### Main Street Advisory Board Agenda – September 7, 2023, 5:00 p.m.

### STAFF REPORT

COA-0116-2023

Renovate and add onto building

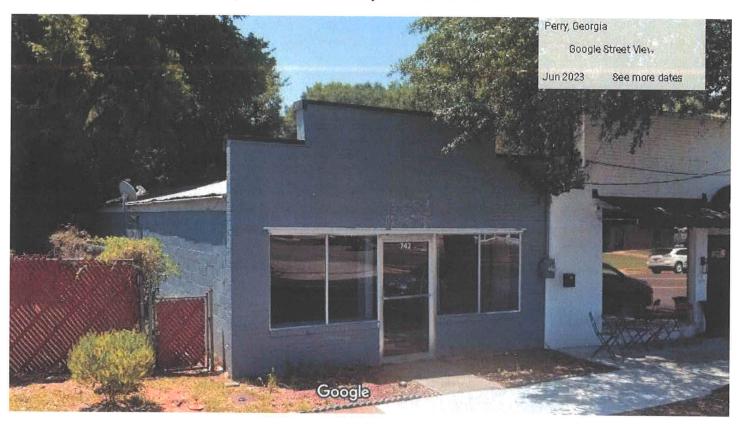
**STAFF COMMENTS:** The proposed colors are not in the approved color palette. It is not clear of the "PIZZA" sign will be painted directly on the façade. Galvalume should not be used as the color of the roof. A light color such as white or light gray in a non-reflective finish is more appropriate.

The proposed 9/12 roof extends above the existing front parapet wall which does not comply with Rehabilitation Roof guidelines which suggests that the existing pitch and shape of a roof should be maintained as seen from the public view and that changes hidden by the parapets may be allowed. The proposed pitched roof terminates in a gable at the front façade extending above the existing parapet. Staff recommends the front end of the roof terminate with a hip so that the roof recedes from the parapet and allows the silhouette of the existing façade to remain.

A clerestory window is proposed in the upper front façade and along the length of the side facades. A horizontal slat fence will identify the walking path along the left side of the building connecting the public sidewalk to a rear outdoor dining area. The clerestory window on the front façade is not inconsistent with the Windows design guidelines.

The existing electrical meter is located on the front façade. With the extensive renovation being made to the building staff suggests the meter be relocated to the left side of the building. This would be consistent with the New Construction Modern Features design guideline suggesting that utility meters should be placed unobtrusively.

**STAFF RECOMMENDATION:** Approval, subject to the following conditions and suggestions, and subject to the Board's determination that paint colors are appropriate:

- 1. A hip roof shall be installed at the front of the building.
- 2. Roof color shall not be "Galvalume" and shall be a non-reflective finish.
- 3. The existing electrical meter should be relocated from the front façade of the building.

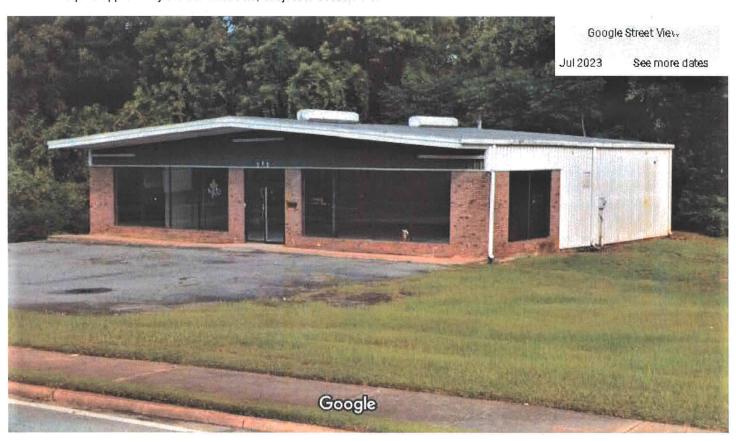
**STAFF COMMENTS:** The proposed colors are not in the approved color palette but are neutral. The "Warm Stone" is a shade between the two colors recently painted on the convenience store at 719 Carroll Street. "Studio Clay" is a lighter shade. The proposal appears to comply with applicable standards.

Since the building has no important architectural details or features, staff suggests the applicant use only one color on the building.

Mr. Stanley mentioned in a phone conversation that he intends to add light sconces to the front of the building but has not chosen them. The Board may want to delegate approval of the sconces to staff.

STAFF RECOMMENDATION: Approval.
